Testimony: Advisory Committee on Reactor Safeguards

Joel Yellin  
Associate Professor of Social Science  
M.I.T.

Safety Study

Frank von Hippel  
Program on Nuclear Policy Alternatives  
Center for Environmental Studies  
Princeton University

Contour Plot  
17 MILES  
CLASS F  
4 mph WIND

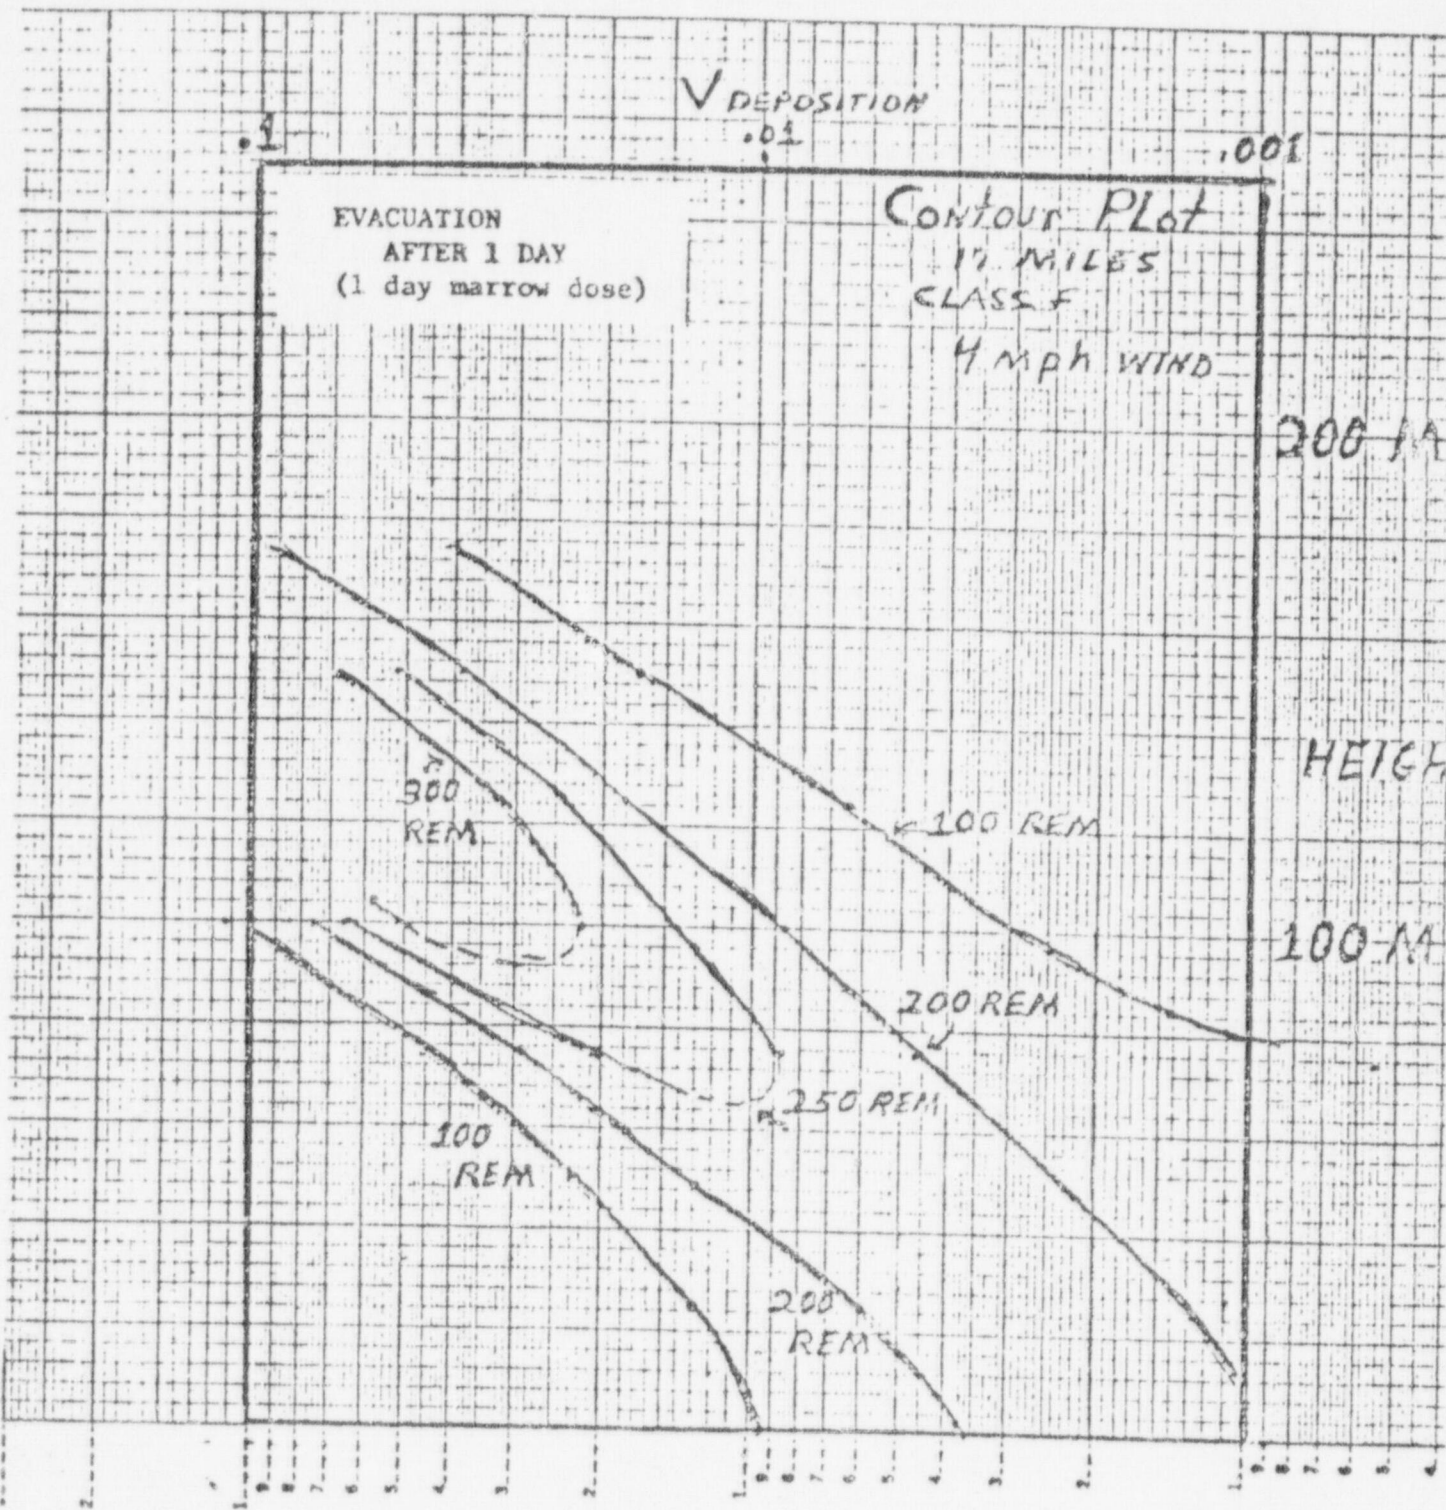
seen that evacuation beyond 20 miles could be important. Figure 11 shows a contour plot in the deposition plume height parameter space for the 1 day bone marrow dose at 17 miles. The horizontal limits of the box are defined by the limits on the deposition velocity given in the RSS study. The vertical scale assumes plume rises of 0 to 250 meters. In the RSS study the plume rise was calculated from the heat content of the released gases using a smoke-stack formula but we are doubtful about the applicability of this formula - as was the RSS group in the first draft of their report - so we treat plume rise as a parameter.
